Technical Service Bulletin

40 Rumbling/creaking noises from front of vehicle while driving

40 18 90 2048266/6 December 13, 2018. Supersedes Technical Service Bulletin Group 40 number 18-86 dated October 4, 2018 for reasons listed below.

Model(s)	Year	VIN Range	Vehicle-Specific Equipment
Q7	2017 - 2018	All	Not Applicable
A6, A7, and A8	2015 - 2018	All	Not Applicable

Figure 1. Hydro-bushing.

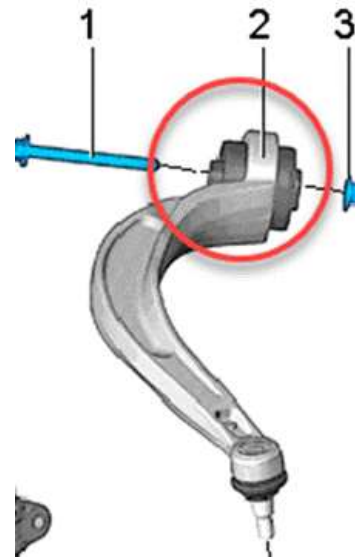
Modified hydro-bushing in control arm link (Figure 1):

- A6/A7 – 12/11/2017, part number 4G0407183B
- A8 - 06/01/2016, part number 4H0407183C
- Q7 - 04/29/2016, part number 4M0407183B

Check the lower guide link of the front axle as it may be the source of the noises. If necessary, replace the hydro-bushing on the guide link.
